Start timing of MRMLC

UNR157-11-06
11^h SIG on R157
09,10 December 2021

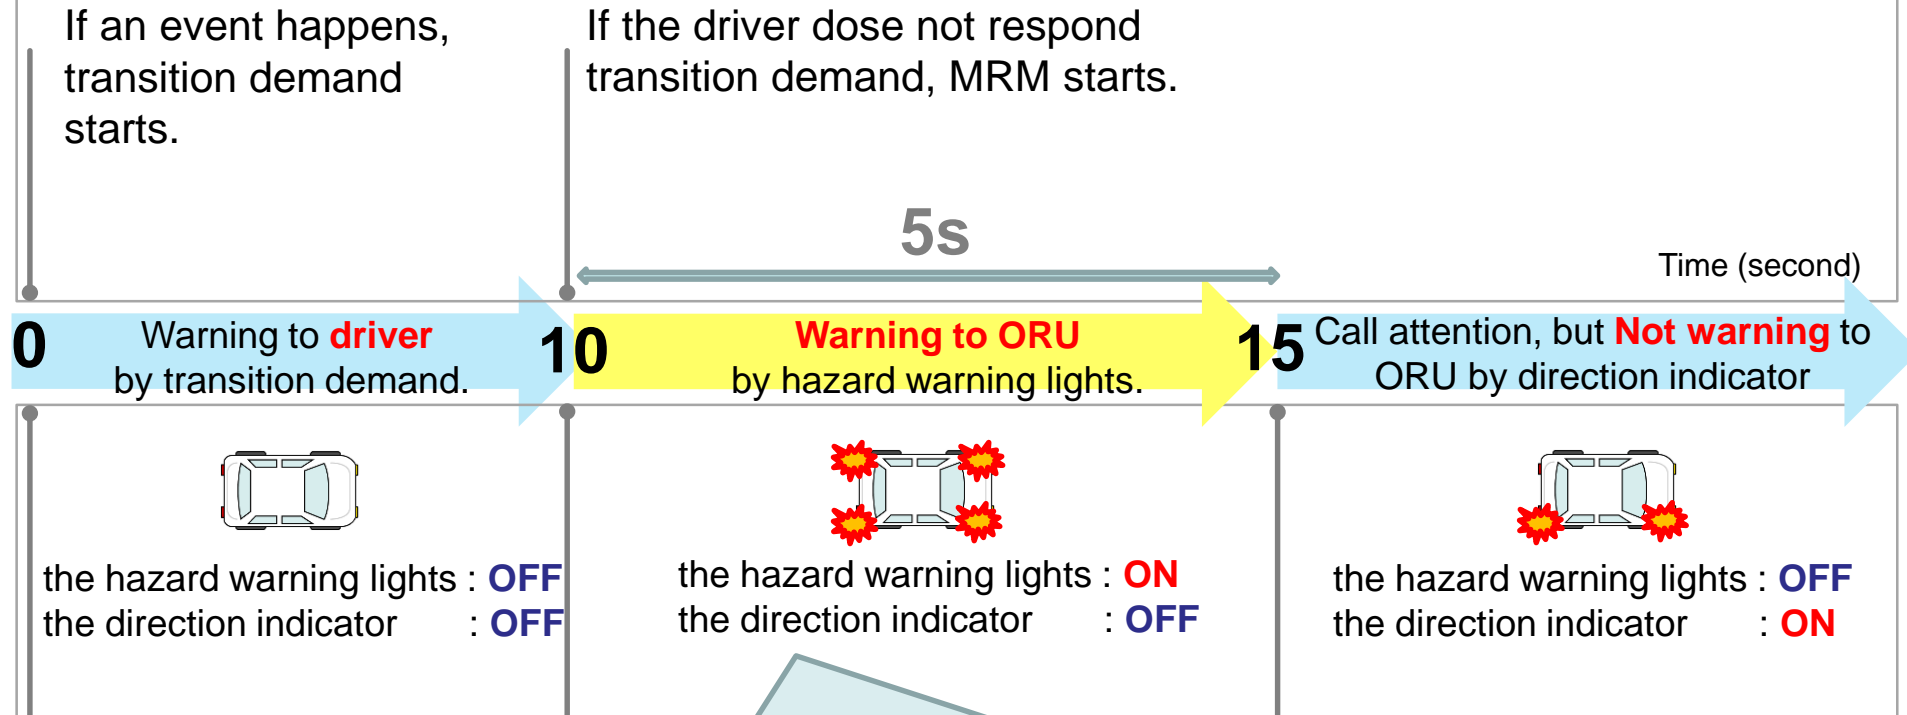
Other road user should be warned that ALKS is in emergent situation because **MRM LC** dose not have enough capability of doing LC safely unless other road users specially take care of the ALKS movement.
Without this "5s", other road user has no chance to be warned before the ALKS starts **MRM LC**.
